Subject: River Bend Station
Docket No. 50-458
License No. NPF-47
Supplement to License Amendment Request (LAR) 1999-30, "IFTS Blind Flange"

Attachment 1 provides the request for applying the 60-day limit and includes requested supplemental information. Attachment 2 provides information regarding IFTS designated operator dose evaluation. Attachment 3 contains Technical Specification mark up pages showing changes to the original submittal.

IFTS Designated Operator Dose Evaluation

Figure 1

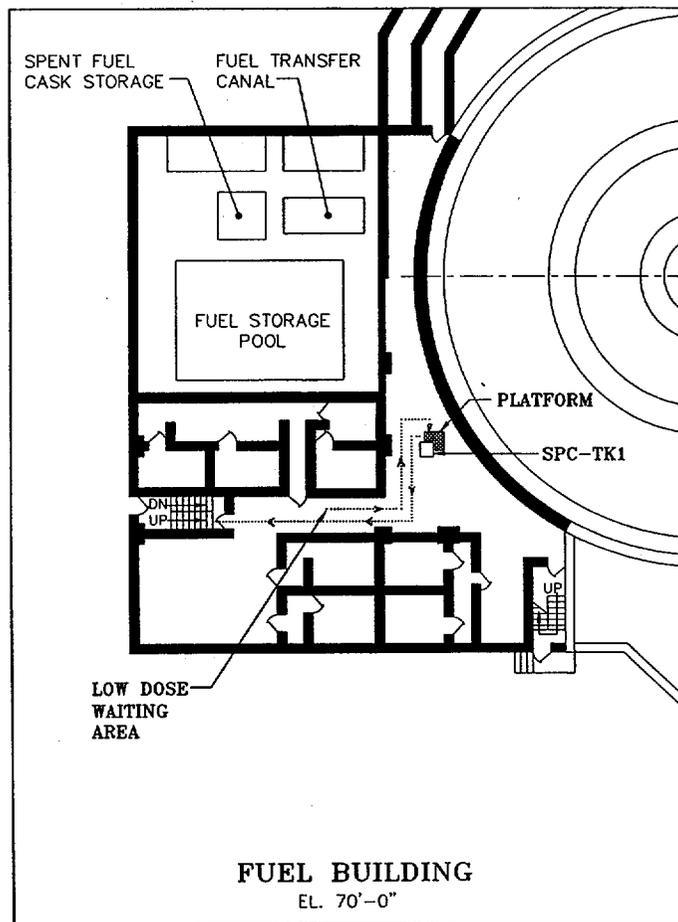
2. The operator will be staged in a low dose waiting area near the IFTS drain tank. The normal operation background dose rate is generally ≤ 2 mR/hr. The two isolation valves are accessible on the platform at the end of the tank itself. The staging area is denoted on the figure 1 below.

4. Upon isolation, the operator will egress the area by proceeding north, climbing the stairs, and exiting the Fuel Building through the door located roughly at lines plant FE and 5 (USAR Figure 1.2-20) and finally proceeding to either the Technical Support Center, the Main Control Room, or the exiting the plant entirely as directed by Operations. Figure 1 below shows the pathway within the fuel building.
